## Dry Creek Greenway Multi-Use Trail

### SRG Site Tour Summary

August 11, 2012, 8:00 to 11:30 am

Sunrise Segment

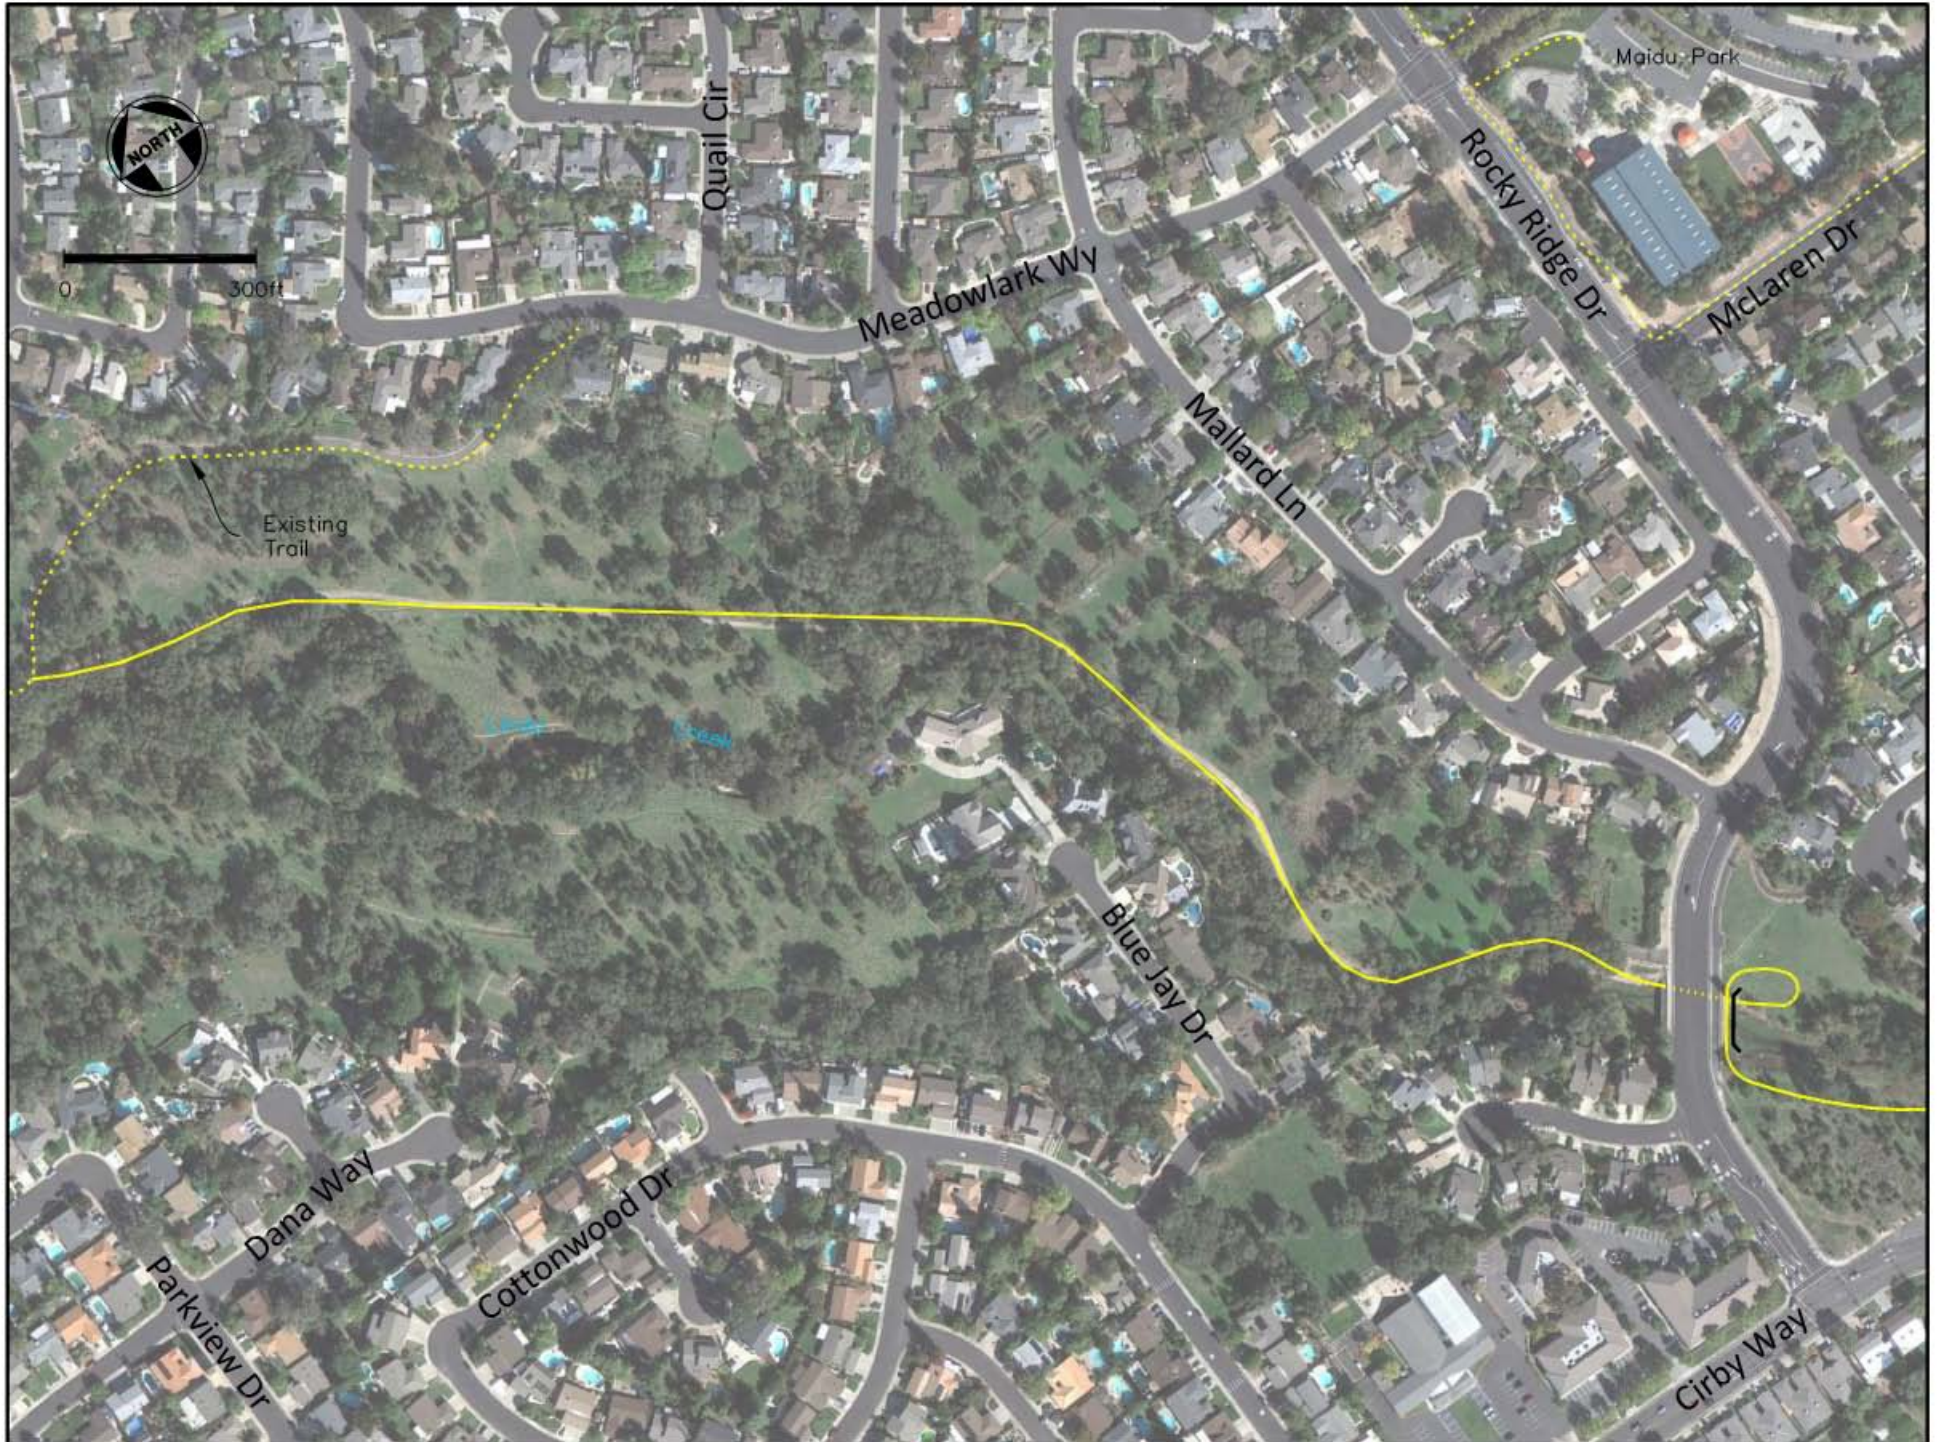
1. Route trail to north side of Linda Creek via a bridge #13, continue trail on existing maintenance road bench under Sunrise Avenue to Oakridge Drive. This option has limited opportunities for trail user access to Sunrise Avenue.
2. Route trail on south side of Linda Creek to an undercrossing of Sunrise Avenue, east of Sunrise continue trail on south side of creek for approximately 500feet, then route trail to north side of Linda Creek via a bridge #14 and then continue the trail to Oakridge Drive. This option has better opportunities for trail user access to Sunrise Avenue.

Questions were raised regarding the location of the trail and the connection to Sunrise Avenue. It was noted that Sunrise Avenue currently does not have bike lanes, providing trail access at Sunrise will allow convenient access for people who work in commercial corridors, it is important to provide access to a major road. City staff noted that City surveys show trail use as a top desired recreation activity in the City. A stakeholder asked where the City owned property lines were in relation to the proposed trail alignments, it was noted that the City owns an easement on the North side of the alignments. A stakeholder noted concern for commercial property values when the trail is so close to buildings, it was noted that a trail can often have a positive effect on property values and can offer tenants a place to walk and enjoy nature during lunch breaks.

<b>Existing Conditions</b>
<ul style="list-style-type: none"><li>• Recommend utilization of existing +/- 1,000' "bench"/existing roadway and right of way/easement(s) on North side of Linda Creek.</li><li>• Proposed option to route path on south side of Linda Creek would create high level of negative impact to existing commercial office properties related to security, maintenance, adverse impacts on leasing, adverse impact on property values.</li></ul>
<b>Constraints</b>
<ul style="list-style-type: none"><li>• Switch back on east Sunrise access increases risk of falls</li><li>• Access at Sunrise appears overly problematic including engineering constraints, close proximity to commercial/office buildings, and expense.</li><li>• The natural access would be Eastwood Park, shoot distance to west (off Cirby). Also, good access to the east via Meadow Oaks.</li><li>• Public parking is highly limited at sunrise. Dangerous traffic conditions exist. Not a good location for bikers to move from/to street to path</li><li>• Completing access at Sunrise would be the transient impact related to various characters who will avoid police and citizen surveillance by utilizing this particular access, if constructed</li><li>• Commercial property owners are very concerned about crime migrating to currently secure, private and pristine environment</li><li>• Environmental impact on creek, plants, trees, wildlife related to bike traffic, trash, illegal use including camping, and erosion. Species: Elderberry, oak trees, steelhead, salmon, turkeys.</li><li>• The trail should run on the north side of the creek in order to keep users away from Sun Down Way commercial properties. What has kept the Meadow Oaks link relatively incident free is that residents' homes look out over the trail. Any suspicious activity day or night is promptly called in to the police department. In this segment there is a significant isolated stretch that will not benefit from watchful eyes after dark.</li><li>• I am greatly concerned at the amount of money, federal or state, that is being spent during such difficult economic times. An expensive entry point at Sunrise Avenue is not necessary as there is an alternative access.</li><li>• I am a cyclist. Sunrise is not used by cyclists. When Mike Dour disagreed with my comment regarding Sunrise, I asked the cyclists on the tour. All answered that they do not use Sunrise - road or sidewalk.</li><li>• The south side with the commercial buildings does not look as appealing. At night it is quiet with no one around to discourage or report suspicious activity. Sunrise Ave. does have a lot of crime. It is the access point from the freeway for "bad guys" entering this part of town. Both sides would need more crime control, lighting, and other precautions. Bicycle access here is complicated and difficult and another expensive structure would be required. Other existing locations may suffice.</li></ul>

- Access to Sunrise transit
- Improved intersection signal [?] at cross streets near trail access point (eg. Marling Coloma?)
- I recommend using the existing shelf along the North side of Linda Creek at the base of the floodwall.

- East of Sunrise: All have access via the Oakridge access point.
- I walked this section again to see more of this segment. It seems that the north side next to the apartments is the better side. There is more land available once you get past the apartments to the parking lot. It was mentioned that there is already a city easement part way down. There would be more eyes and ears around a parking lot to keep a watch on things. A fence would also be good to address safety and separation.
